MOORE PUBLIC SCHOOLS -
ASC BOARDROOM and STORM SHELTER BUILDING
Moore Public Schools - Moore, Oklahoma
AGP - Moore, Oklahoma

ADDENDUM NO. 2
November 4, 2026

C902

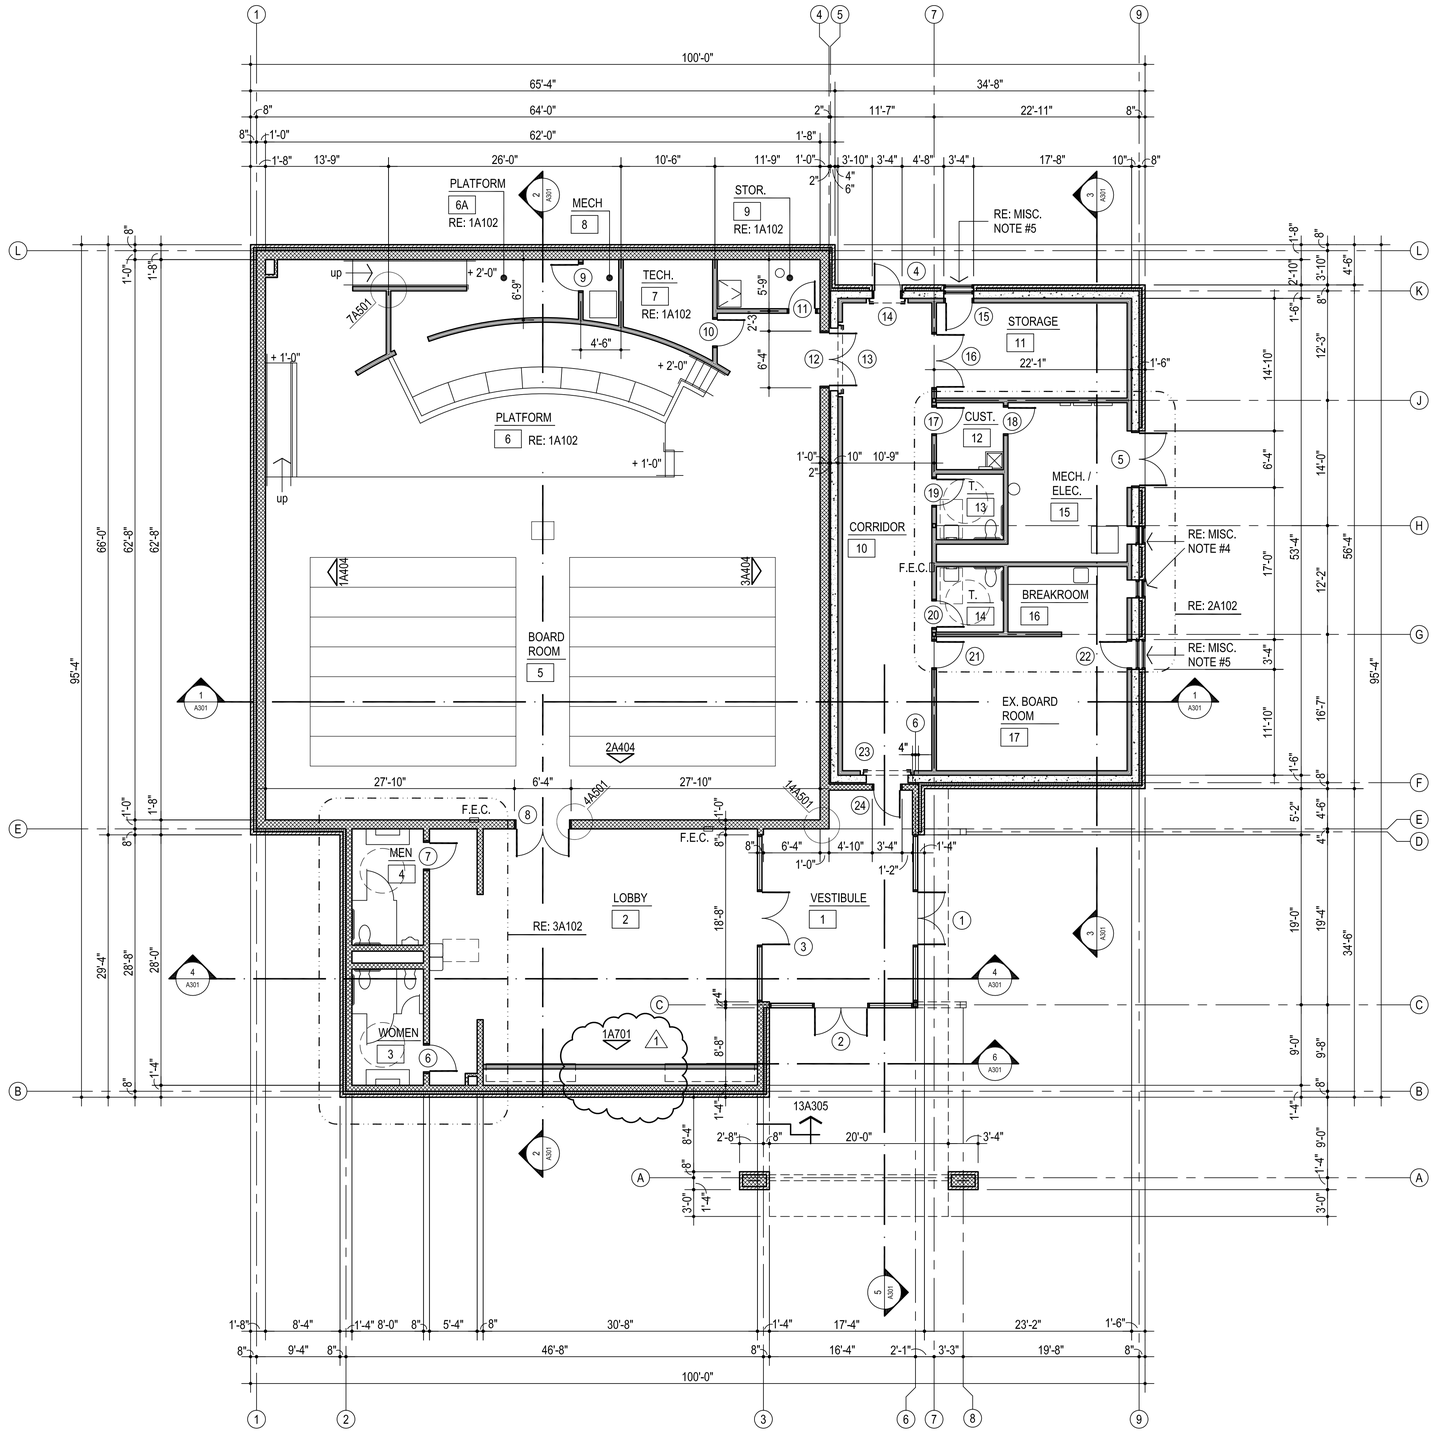
3. Sheet A902, Sign Location Plan & Details: refer to new sheet for site sign relocation and replacement / editing. Refer to new attached replacement drawing.

New wall sign at 4th Street with cast letters, refer to new Sheet C902.

A101

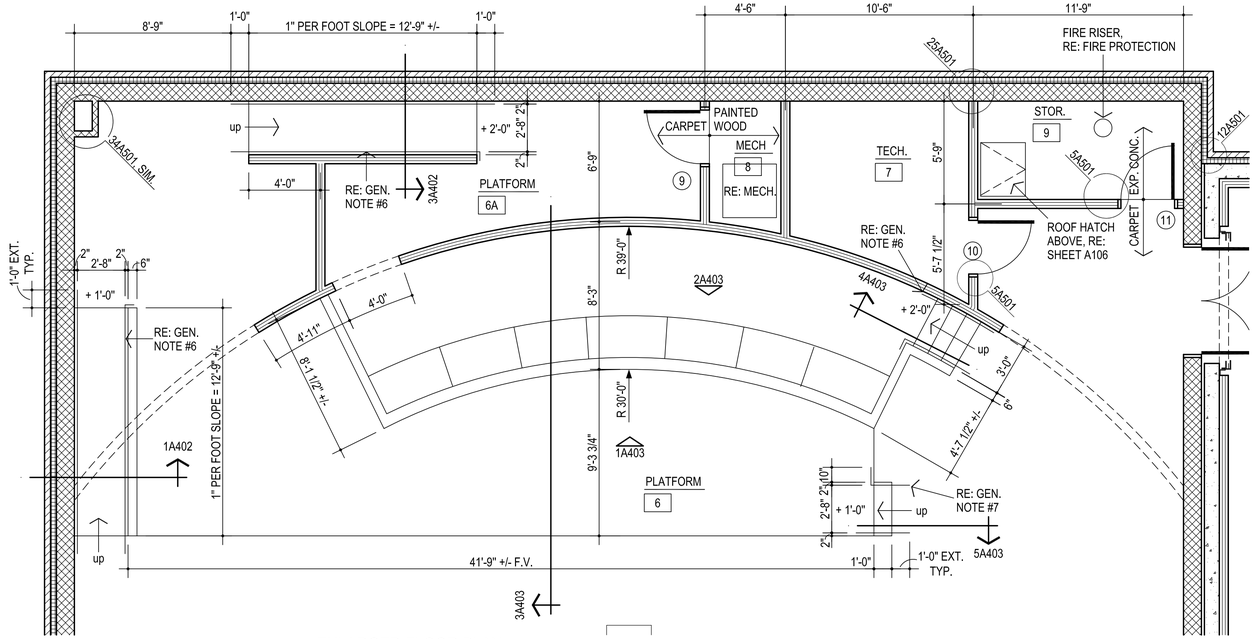
1. Sheet A101, Detail #1, Floor Plan: revise display cabinets at east wall of Lobby, Room #2. Refer to new attached replacement drawing.

4 ENLARGED FLOOR PLAN ROOM #2
1/8" = 1'-0"
1
NORTH

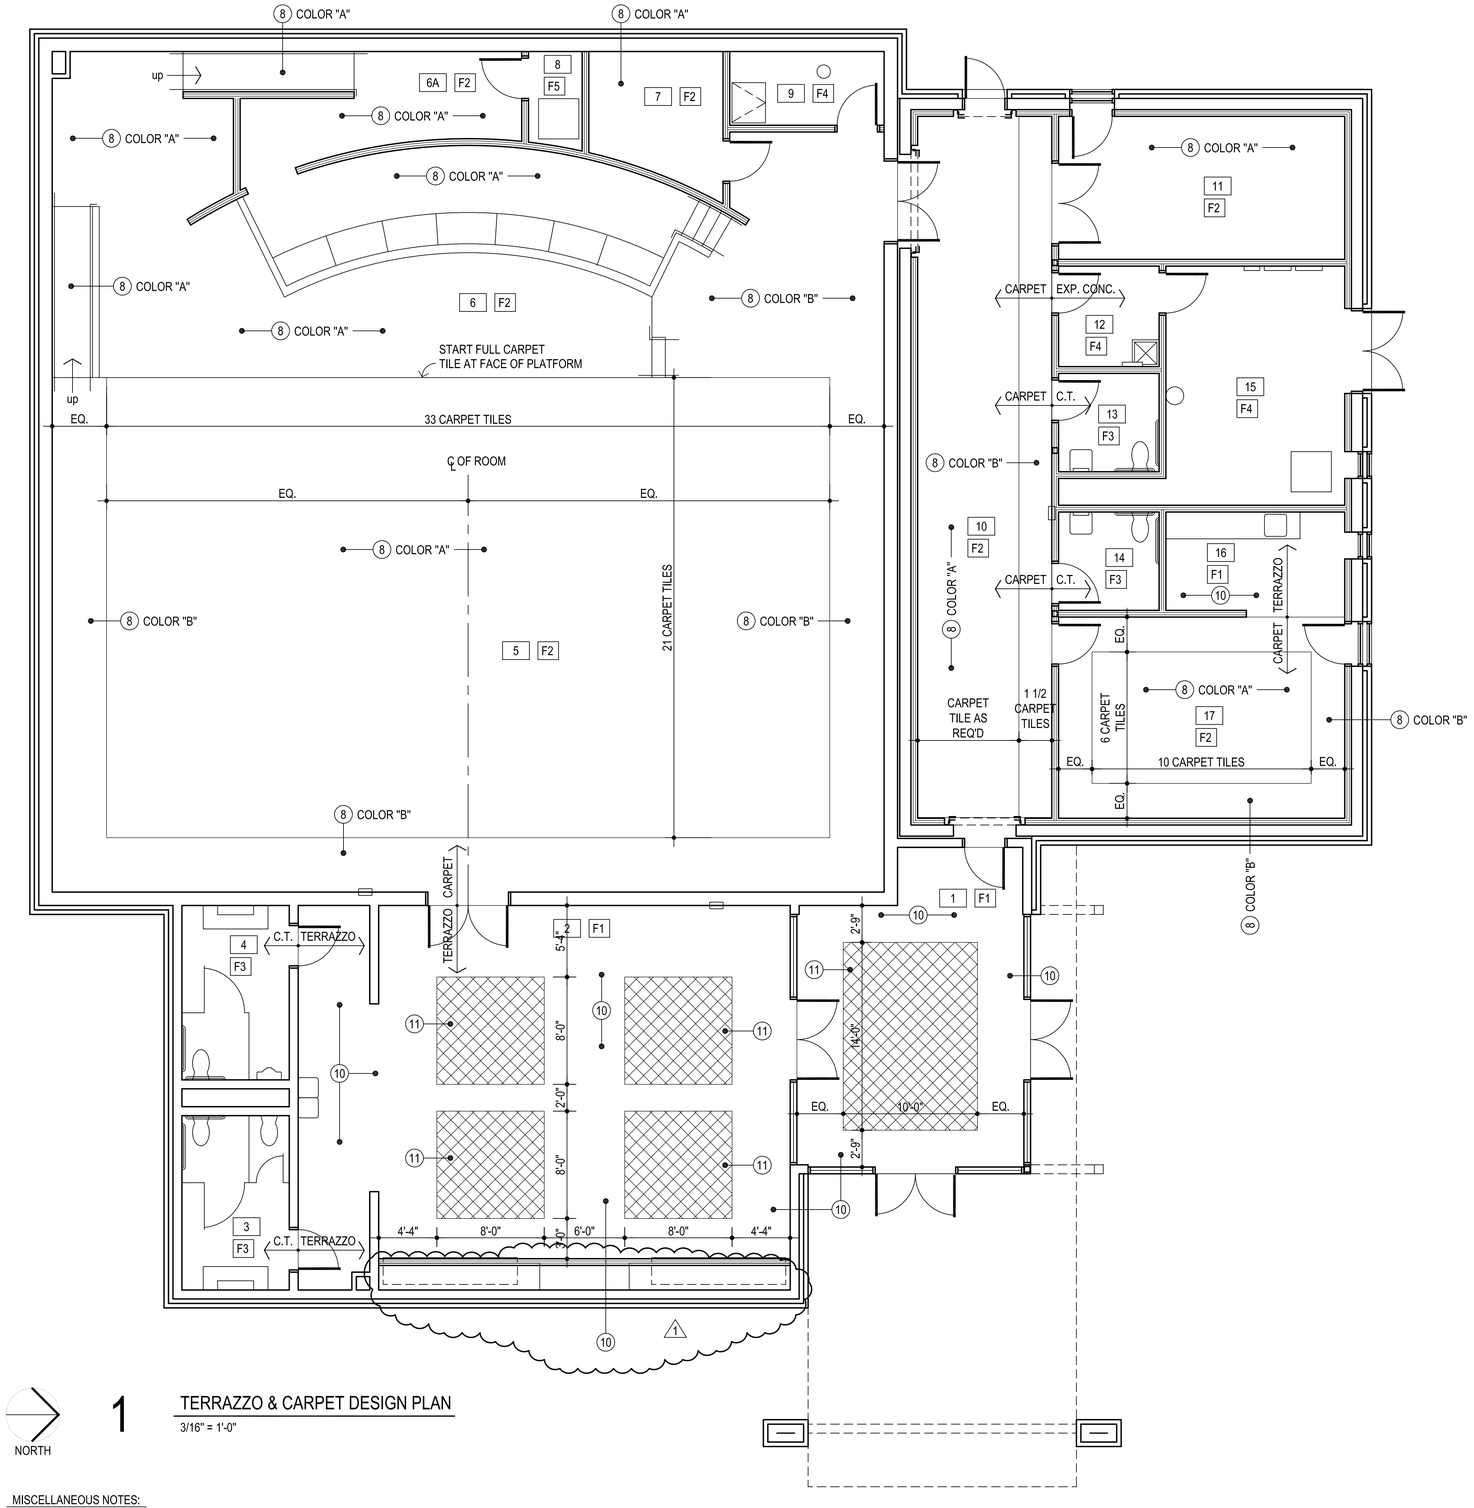
2. Sheet A102, Detail #4, Enlarged Floor Plan Room #2: added enlarged floor plan as per attached revised drawing.

A103

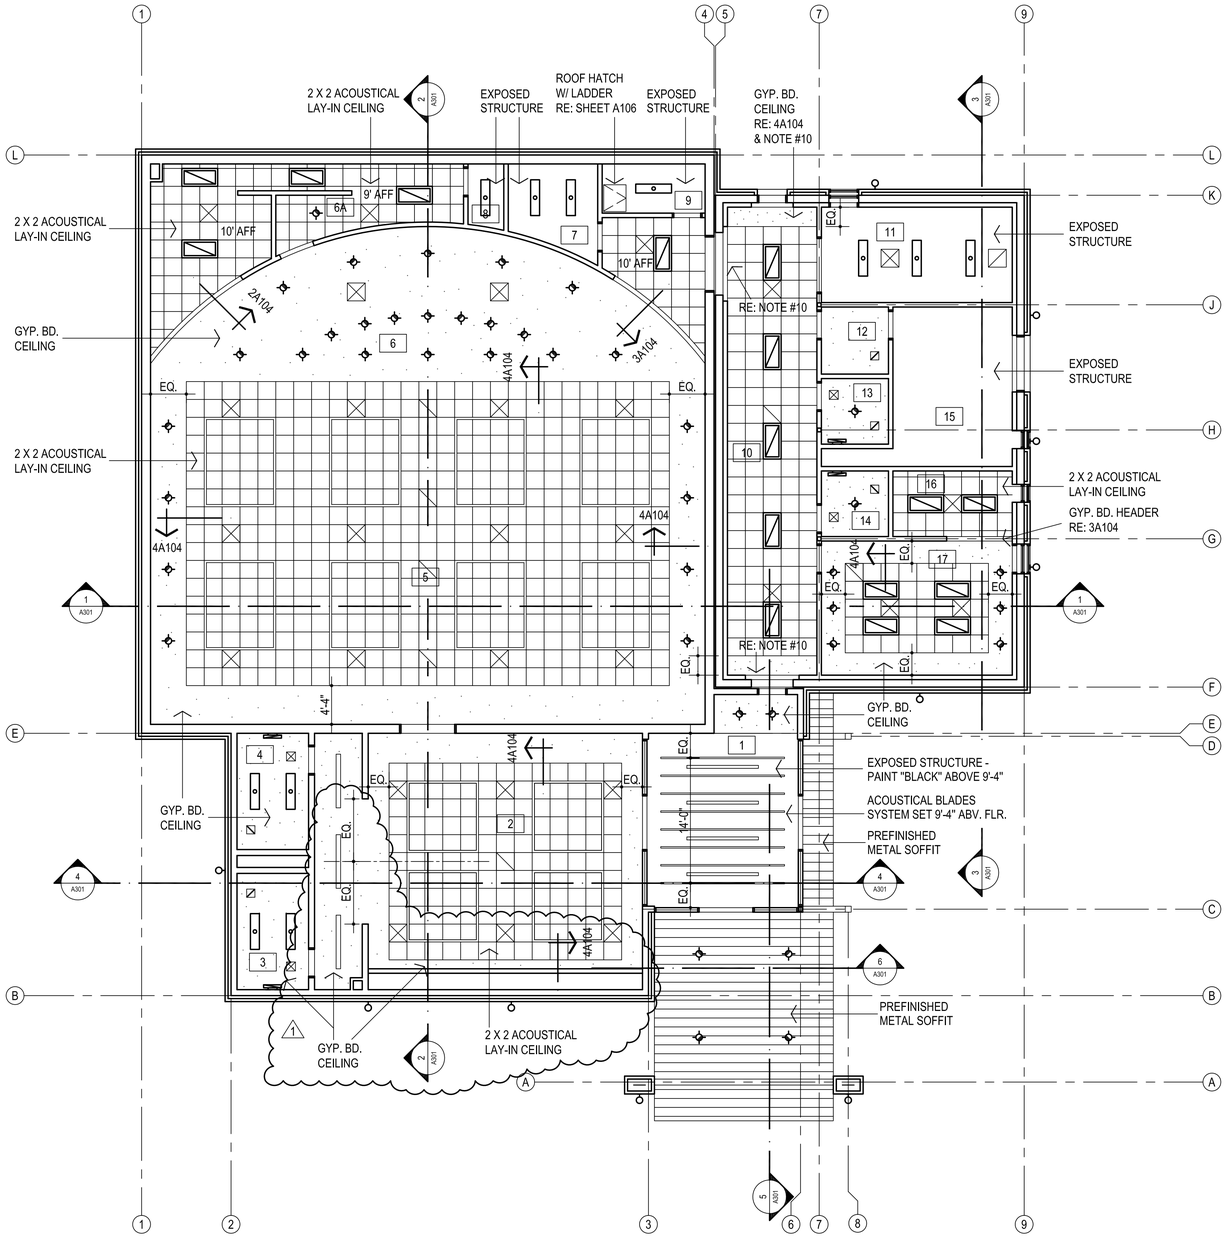
3. Sheet A103, Detail #1, Terrazzo & Carpet Design Plan: revise display cabinets at east wall of Lobby, Room #2. Refer to new attached replacement drawing.

A104

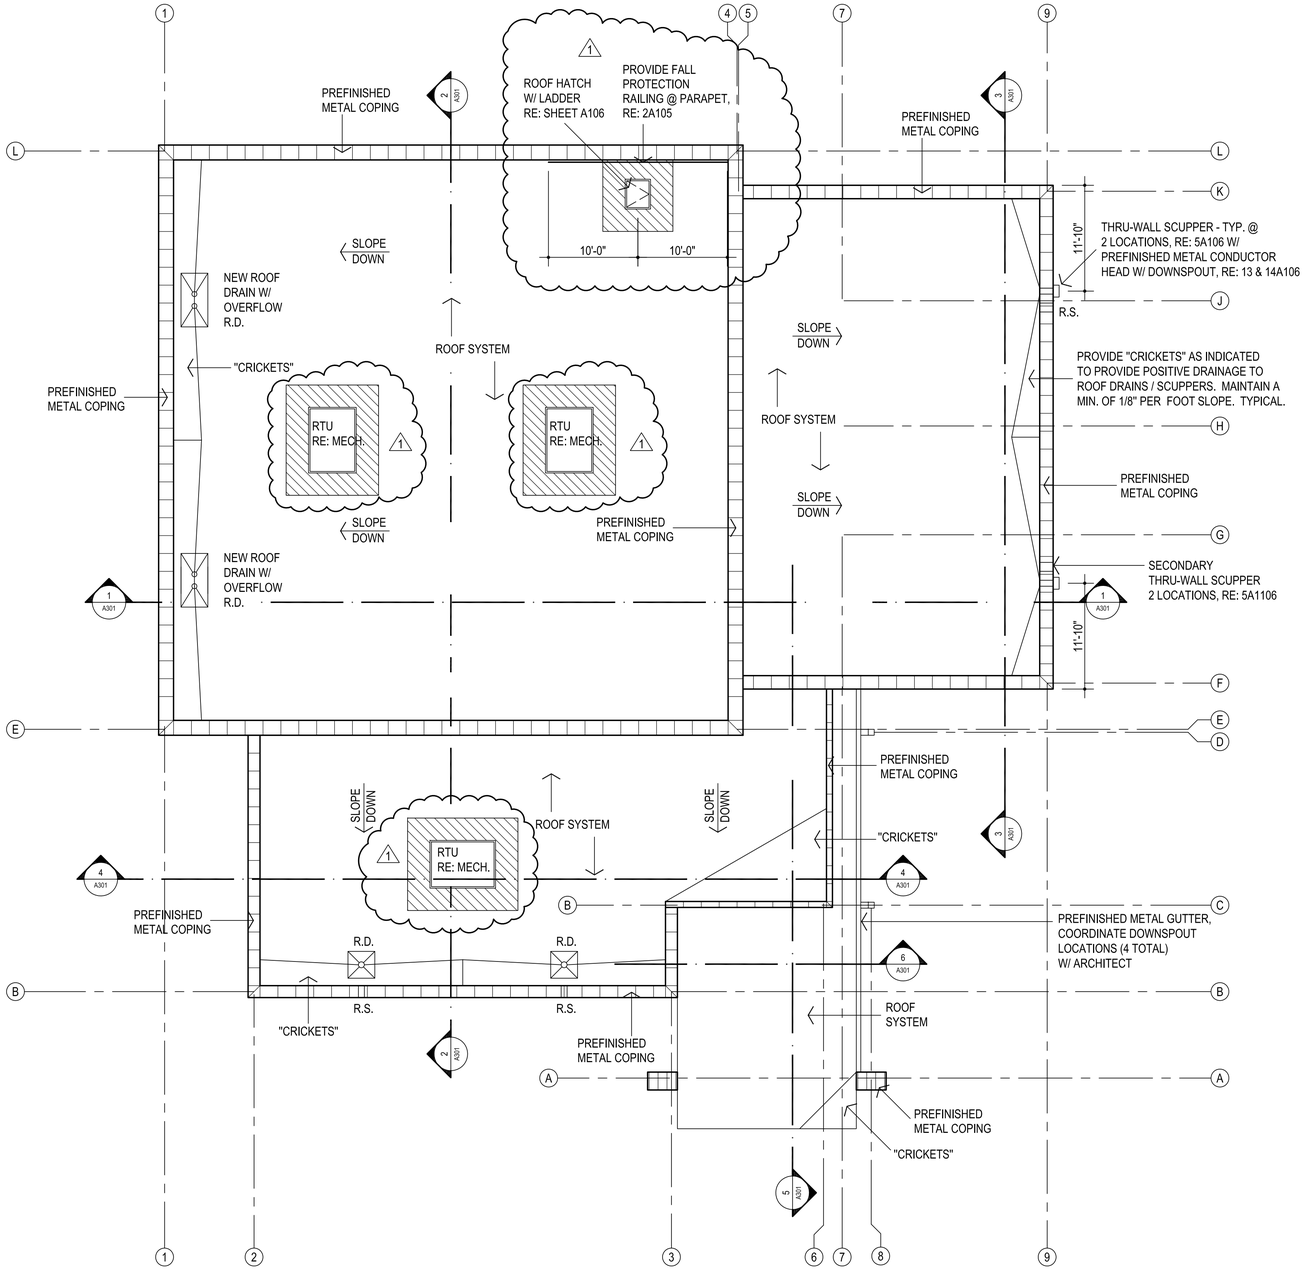
4. Sheet A104, Detail #1, Reflected Ceiling Plan: revise ceiling at display area at east wall of Lobby, Room #2. Refer to new attached replacement drawing.

A105

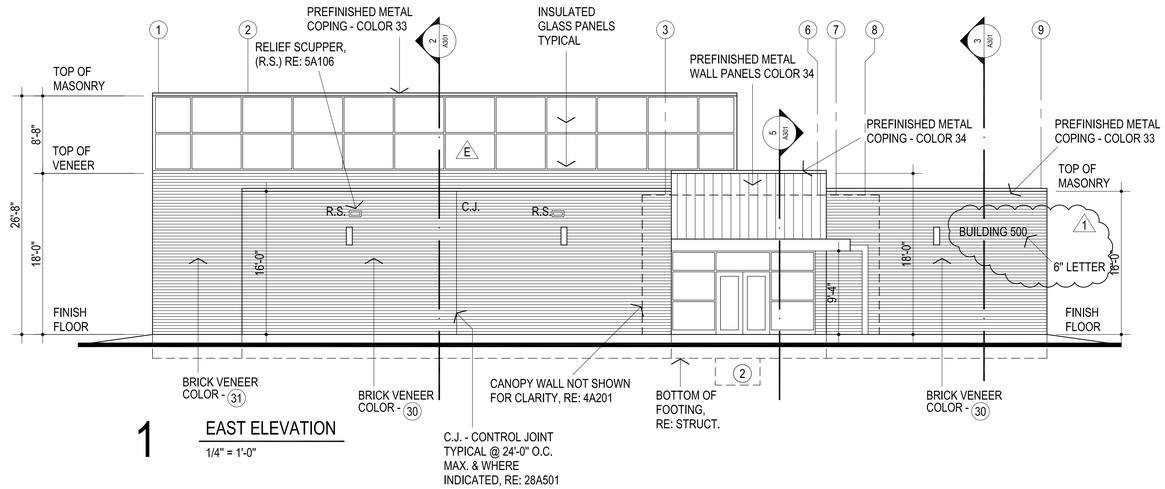
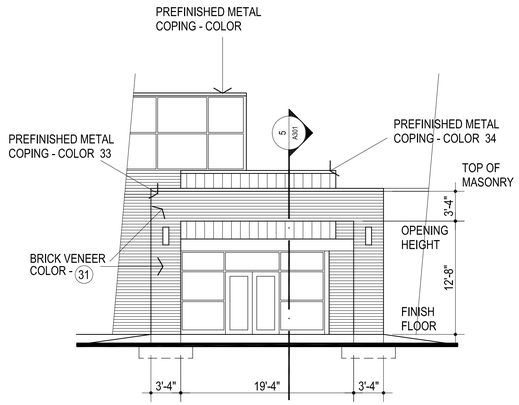
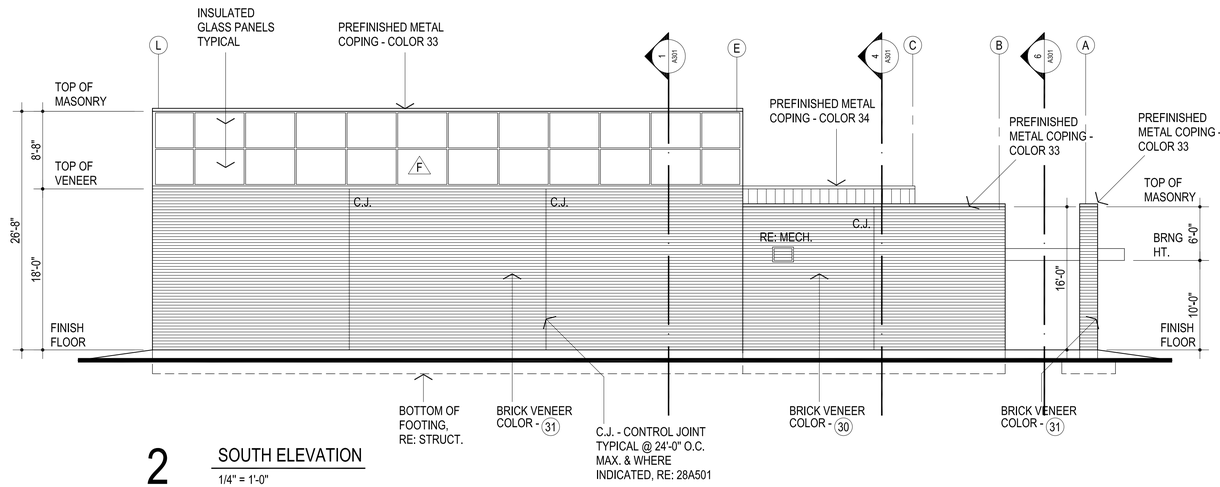
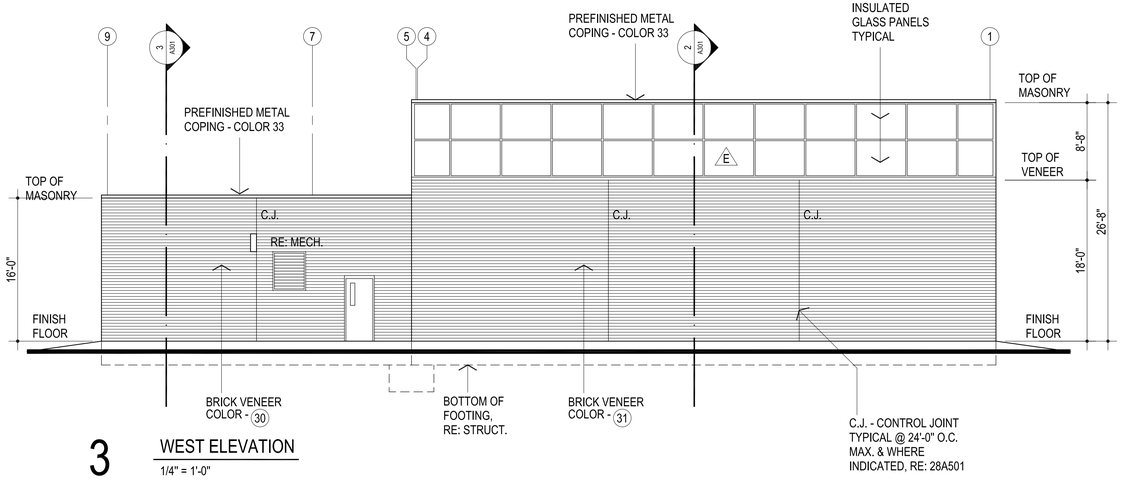
5. Sheet A105, Detail #1, Roof Plan / new Detail #2, Parapet Safety Railing: provide fall protection railing at west side of roof hatch to meet all applicable codes and standards and added roof top units with walkway pads indicated. Refer to new attached replacement drawing.
